Access Compliance Report

Public Rights-of-Way

(Curb Ramps)

Intersection ID: 53210	Main Street: HARPER_CT	Cross Street: PARK_SOUTH_DR	Location: SW
ADA ID: E8CCE5EB2F47	Ramp Type: PerpDiag	Initial Pass/Fail: Fail	Overall Compliance: No Severity Score: 13.75

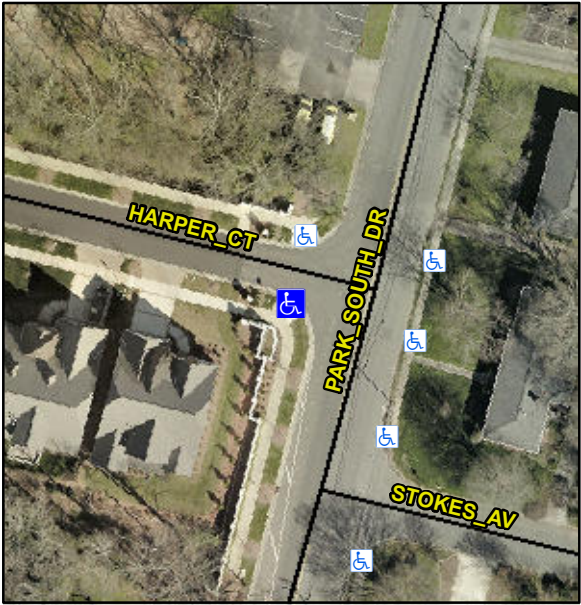
Codes/Mitigation Info/Possible Solution			Field Measurements/Component Compliance			
	Possible Solutions:		Compliance	Description	Data	
	Remove & Replace Curb Ramp With Two New Directional Ramps or Equivalent.		N/A	Ramp Length (in)	94.0	No
			Yes	Ramp Width (in)	48.0	No
			N/A	Flare Type LT	N/A	N/A
			N/A	Flare Slope LT (%)	N/A	N/A
			N/A	Flare Traversable LT?	N/A	N/A
			N/A	Landing Length (in)	N/A	N/A
			N/A	Landing Width (in)	N/A	N/A
			N/A	Landing Slope (%)	N/A	N/A
			N/A	Landing X Slope (%)	N/A	N/A
<p>Surveyor Notes:</p> <p>N/A</p> <p>PROW/ADA:</p> <p>R304.2.2, R304.5.3</p>			N/A	Flare Type RT	N/A	N/A
			N/A	Flare Slope RT (%)	N/A	N/A
			N/A	Flare Traversable RT?	N/A	N/A
			N/A	DWS Provided?	N/A	N/A
			N/A	DWS Contrast?	N/A	N/A
			N/A	DWS Length (in)	N/A	N/A
			N/A	DWS Full Width?	N/A	N/A
			N/A	DWS Offset (in)	N/A	N/A
			N/A	Shared Landing?	N/A	N/A
			N/A	Gutter Ponding?	N/A	N/A
<p>Total Cost:</p> <p>\$ 3200.00</p>			N/A	Gutter Lip Ht (in)	N/A	N/A

N/A	Painted X Walk1?	No	N/A
				X Walk 1 Direction	To E	X Walk 2 Direction
			N/A	X Walk 1 Width (in)	N/A	N/A
				X Walk 1 Slope (%)	3.5	X Walk 2 Slope (%)
				X Walk 1 X Slope (%)	1.2	X Walk 2 X Slope (%)
			N/A	Ramp inside XWalk1?	N/A	N/A
				Road Slope (%)	1.9	N/A
				Road X Slope (%)	3.7	N/A
			N/A	Any Obstructions?	N/A	N/A
				Obstruction Type		
					N/A	N/A
					Yes	Surface Condition? (G/P)
						Good
